Access Compliance Report

Public Rights-of-Way

(Curb Ramps)

Intersection ID: 44928	Main Street: ACORN_FOREST_LN	Cross Street: TWIN_BROOK_DR	Location: NE
ADA ID: 804E0E96C082	Ramp Type: Perp	Initial Pass/Fail: Fail	Overall Compliance: No
Severity Score: 13.75			
Codes/Mitigation Info/Possible Solution		Field Measurements/Component Compliance

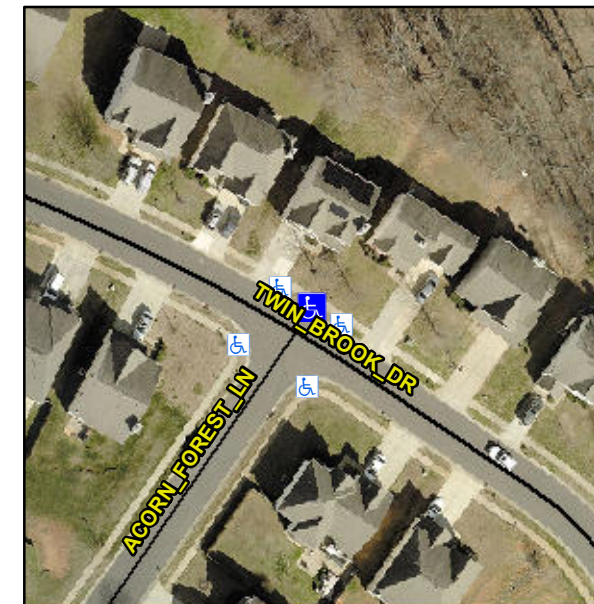
Not Found, R304.2.2

Compliance	Description	Data	Compliance	Description	Data
N/A	Ramp Length (in)	48.0	No	Ramp Slope (%)	9.4
Yes	Ramp Width (in)	49.0	Yes	Ramp XSlope (%)	3.0
N/A	Flare Type LT	N/A	N/A	Flare Type RT	N/A
N/A	Flare Slope LT (%)	N/A	N/A	Flare Slope RT (%)	N/A
N/A	Flare Traversable LT?	N/A	N/A	Flare Traversable RT?	N/A
N/A	Landing Length (in)	N/A	N/A	DWS Provided?	N/A
N/A	Landing Width (in)	N/A	N/A	DWS Contrast?	N/A
N/A	Landing Slope (%)	N/A	N/A	DWS Length (in)	N/A
N/A	Landing X Slope (%)	N/A	N/A	DWS Full Width?	N/A
N/A	Landing Curb? (Y/N)	N/A	N/A	DWS Offset (in)	N/A
N/A	Shared Landing?	N/A			
N/A	Gutter Ponding?	N/A	N/A	Gutter Slope (%)	N/A
N/A	Gutter Lip Ht (in)	N/A	N/A	Gutter X Slope (%)	N/A
N/A	Painted X Walk1?	No	N/A	Painted X Walk2?	N/A
	X Walk 1 Direction	To S		X Walk 2 Direction	N/A
N/A	X Walk 1 Width (in)	N/A	N/A	X Walk 2 Width (in)	N/A
	X Walk 1 Slope (%)	3.4		X Walk 2 Slope (%)	N/A
	X Walk 1 X Slope (%)	3.1		X Walk 2 X Slope (%)	N/A

Remove & Replace Entire Ramp.
